I-70 West Vail Pass Auxiliary Lanes
Eagle County, Colorado
Value Engineering Study Report - Final

R | 0
May 20, 2021

Project: NHPP 0702-404 / FBR 0702-403
Subaccount: 23982 / 23929

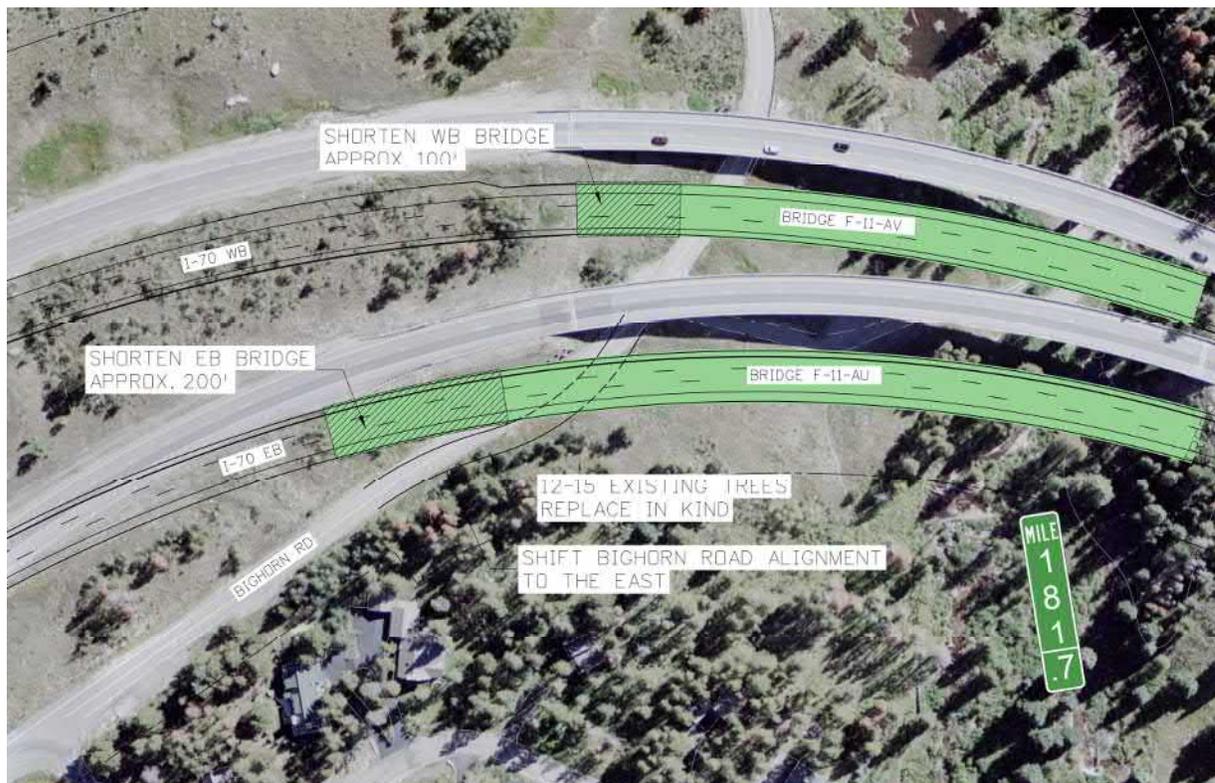
Under this concept, the alignment of Big Horn Road would be adjusted so that the west abutments of both WB I-70 bridges could be shifted east, shortening the bridge spans. It appears the EB structure could be shortened by approximately 200' and WB could be shortened by 100'.

Big Horn Road would need to be re-constructed through the realignment area. The roadway realignment would impact approximately 12 to 15 trees and these could be replaced in-kind within the nearby ROW. Where the currently planned structures are shortened, it would be necessary to provide embankment fill and this could be done using excess material which is anticipated to be available from the project.

Idea 29

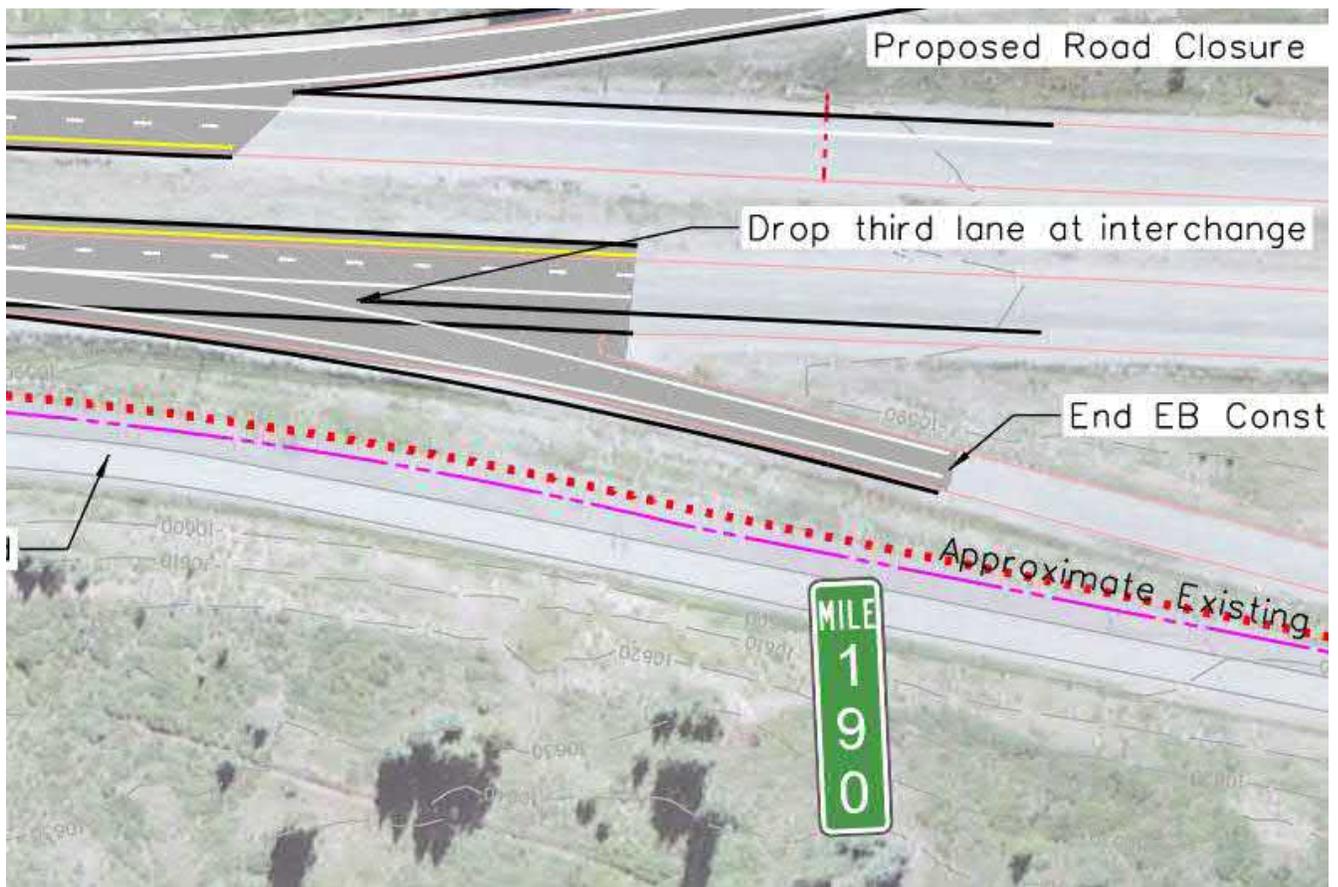
Proposal 3: At the east end of the project, Exit 190 EB, provide a recovery lane beyond the exit to improve operations, especially with trucks merging.

This measure would allow for a recovery area beyond Exit 190 for errant vehicles, per CDOT's desired practice. It could also be configured as a lane taper beyond the exit to improve

Idea 30

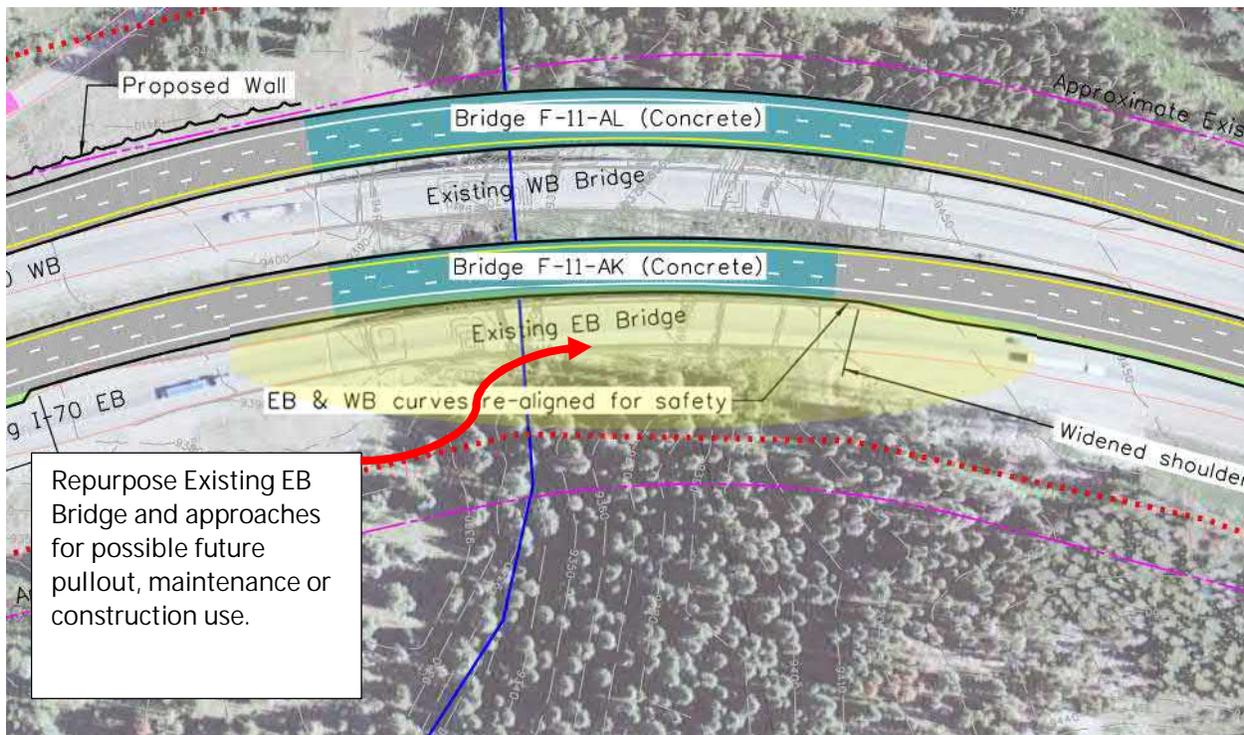
This item encourages the design team to determine if it is desirable to retain existing bridge structures in lieu of demolition. Repurposing a structure would represent a sustainable design approach but would need to be considered in light of the advantages and disadvantages outlined above.

Figure 1 - Example of Box Culvert for Emergency Vehicle Turn Around half way between Silverthorne and Eisenhower Tunnel

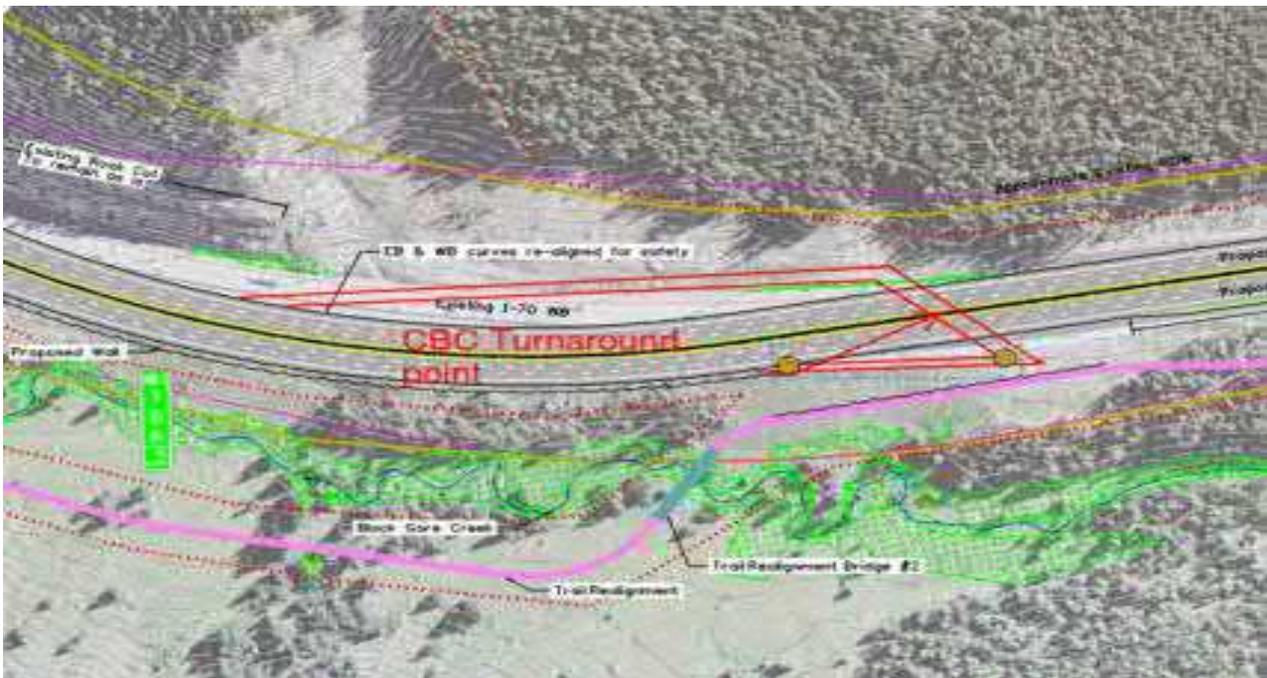
This proposal suggests an EB turnaround point half way up the pass that could be used either daily, only during incidents to bleed off the highway, only for cars not trucks, all vehicles, at all times, only as directed by police, designed for single lane use and large enough for commercial vehicles, etc. The overall plan set shows 5 median turn around points, but these would not be useful for general purpose traffic. If general purpose traffic is to turn around during incidents and with the direction of the police, it puts all of those involved in harm's way and in unsafe conditions. It also at times can force a closure in the opposite direction to bleed off the highway using the turnaround which congests the opposite direction of traffic and requires additional resources and coordination. Therefore, the drivers and police have very little choice than to sit on the highway.

A similar turnaround point is on I-70 in the EB direction on the Eisenhower Tunnel grade but is only used by emergency vehicles and is a one-way culvert box as see in the picture on the next page. This turnaround is not signed for use and it is not clear how it is used and by whom. The box large enough to fit a fire truck. The box can fill with ice making maintenance difficult.

Idea 47

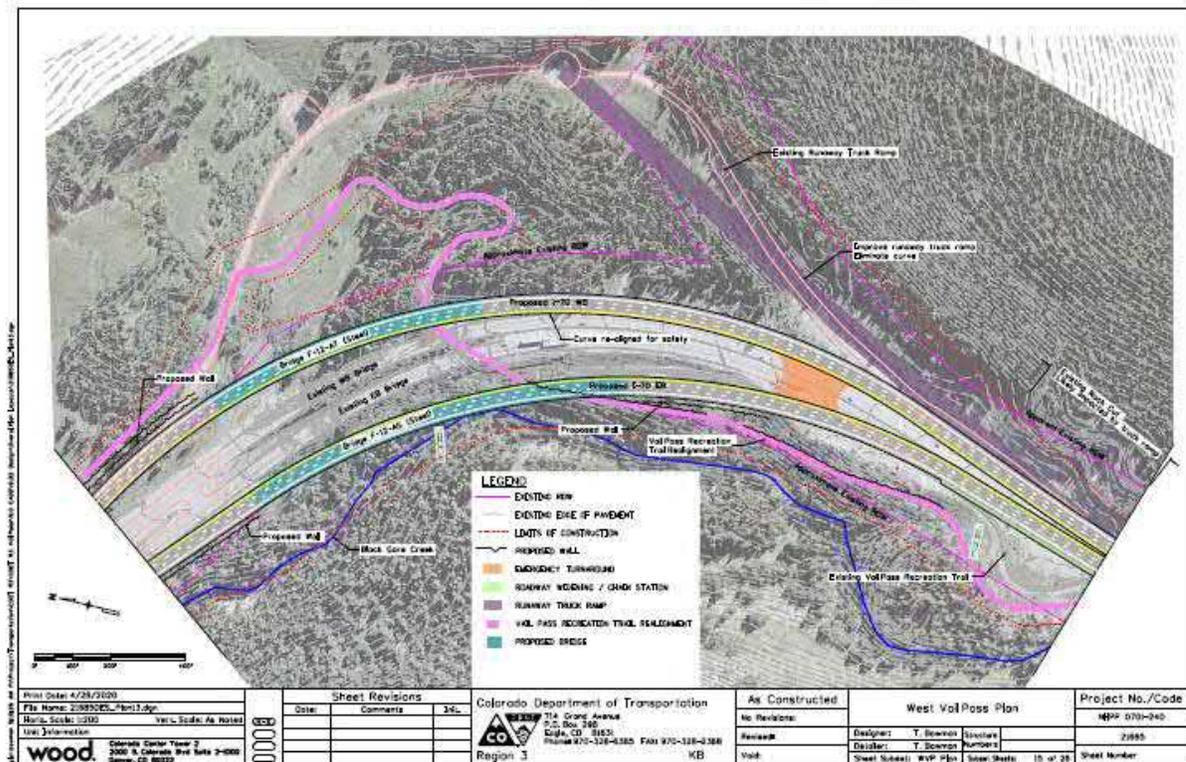
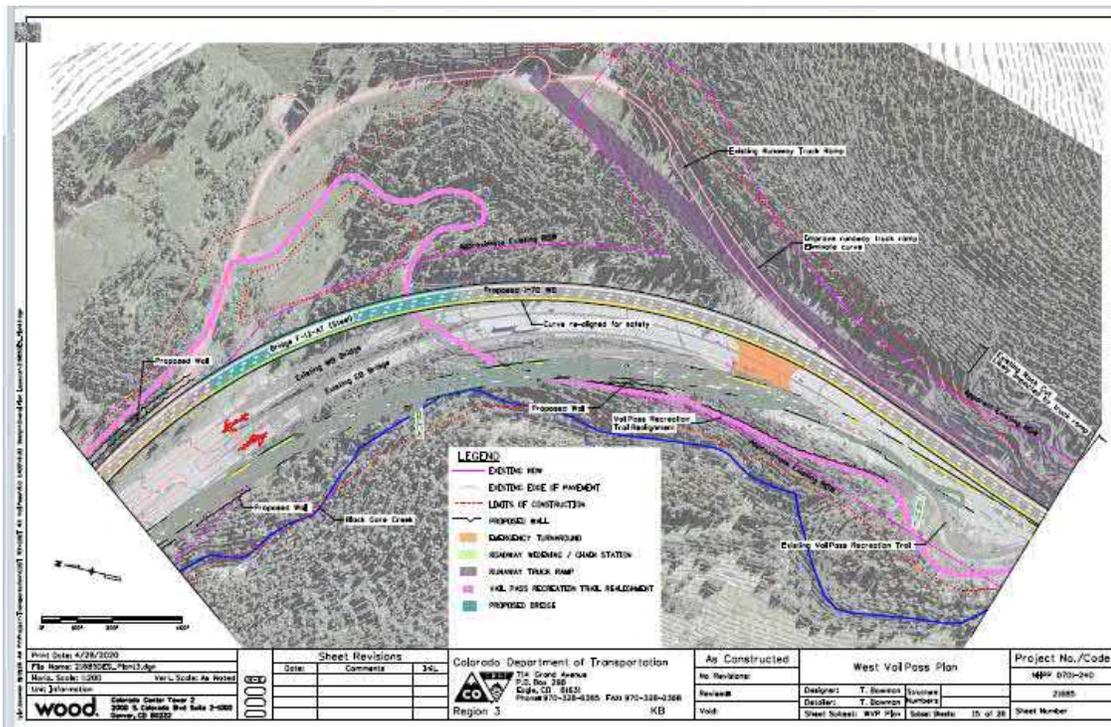
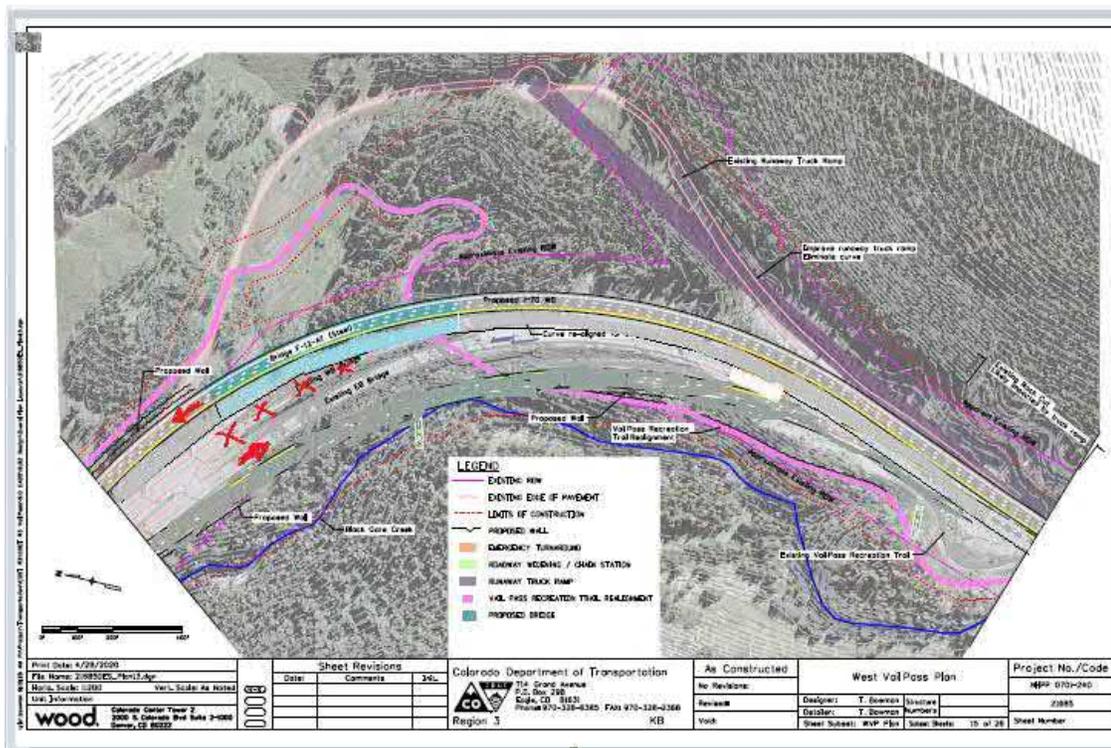
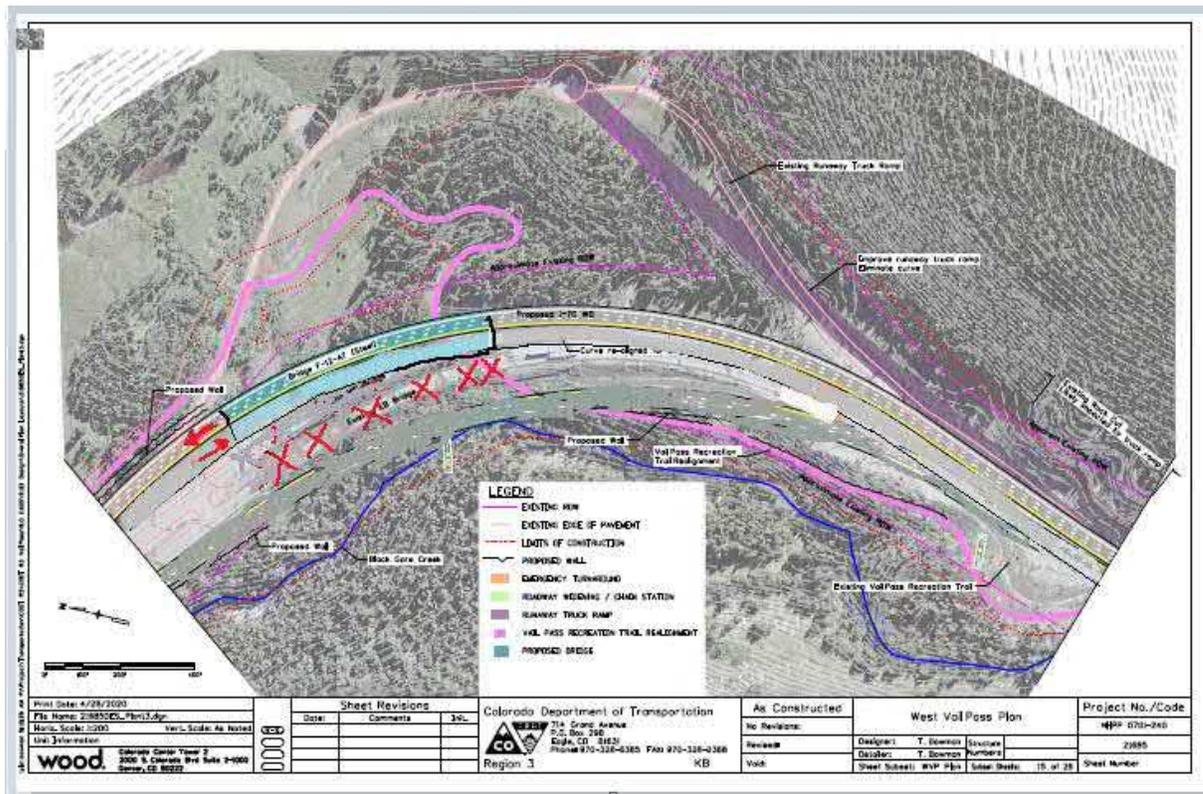
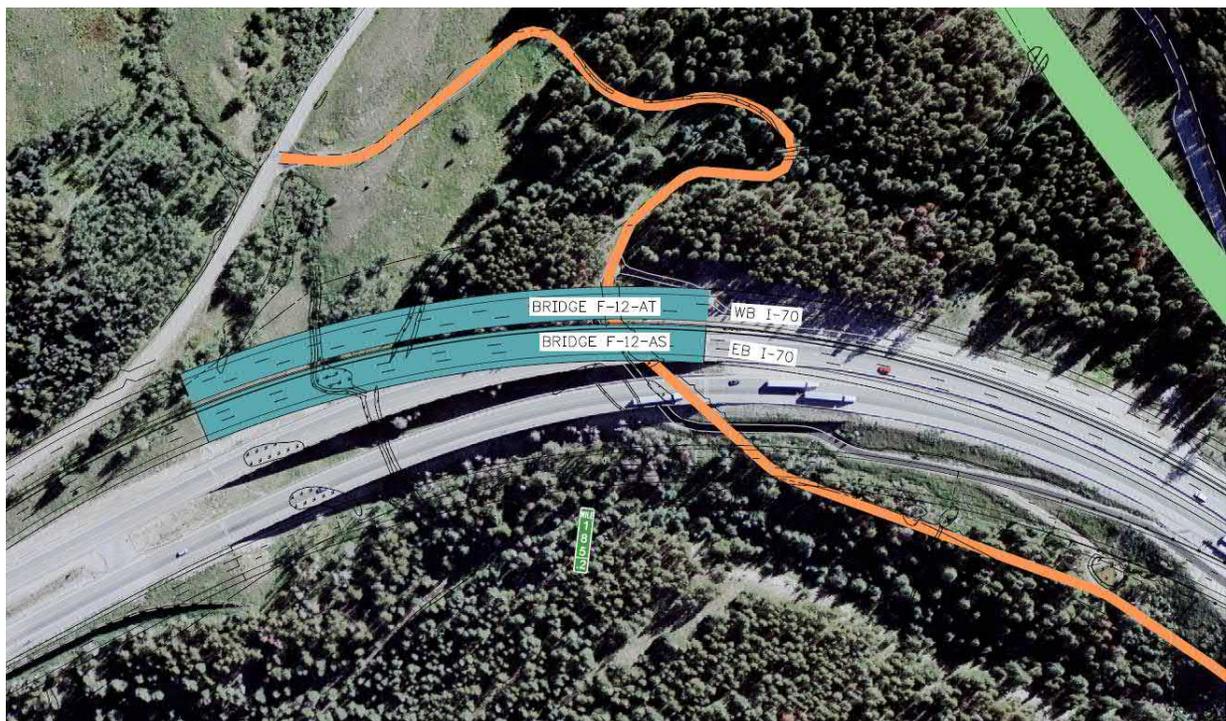
The current design constructs a new WB bridge at a larger radius adjacent to the current WB bridge. It also constructs a new EB parallel to the existing EB bridge with a larger radius.

The Proposed Design constructs the same new WB as the original Design. EB & WB traffic remains on their respecting existing during construction.

Once the new WB bridge is complete, WB traffic is shifted on to it. The existing WB bridge is demolished and a new EB Bridge is constructed parallel to it. EB traffic remains on its existing bridge.

Once the new EB bridge is complete, EB traffic is shifted on to it. The existing EB bridge is demolished.

Idea 48

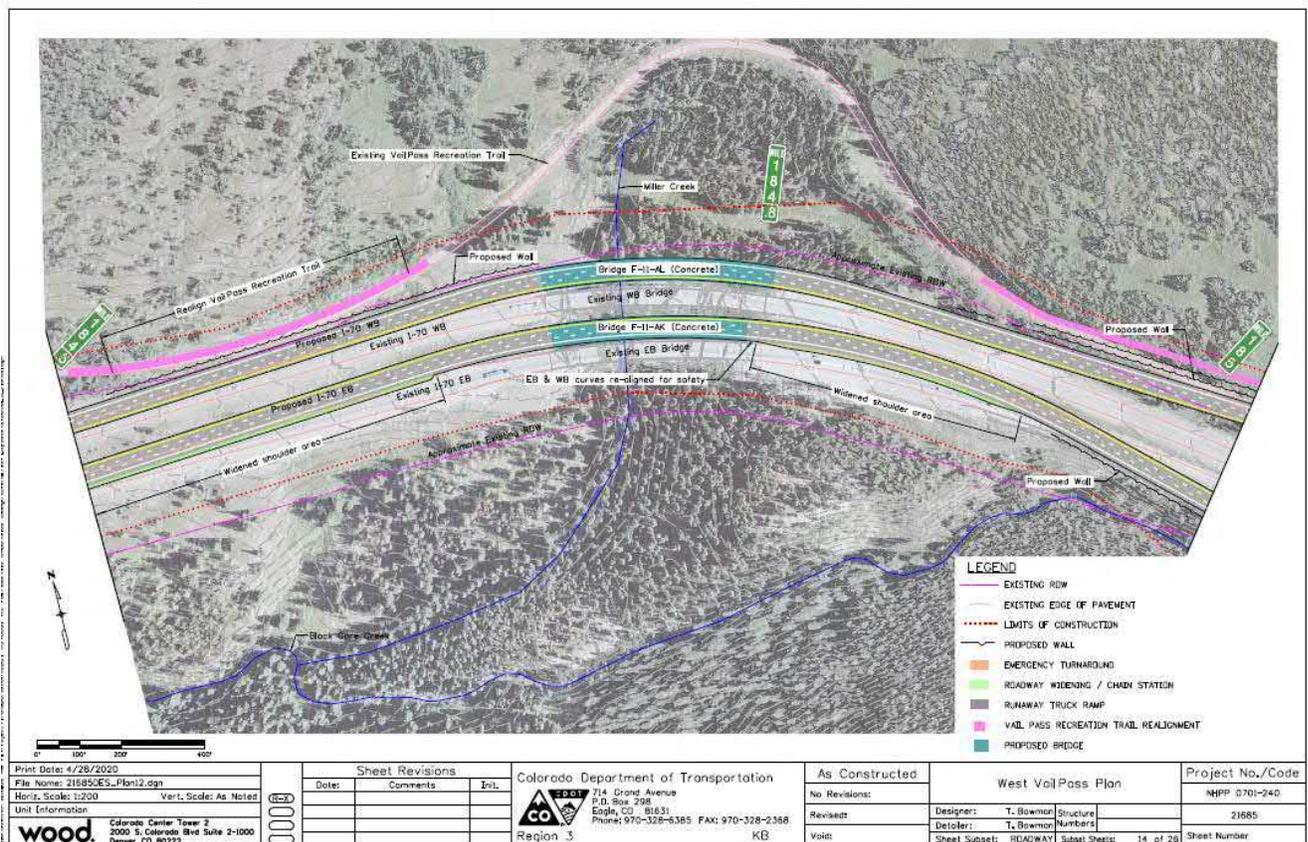
The new WB and EB alignments are parallel (or concentric) to the existing alignments. This makes construction straight forward.

Upon review of the Google Earth KMZ file, it appears the design team has also adopted this idea of building the new EB alignment on its existing alignment.
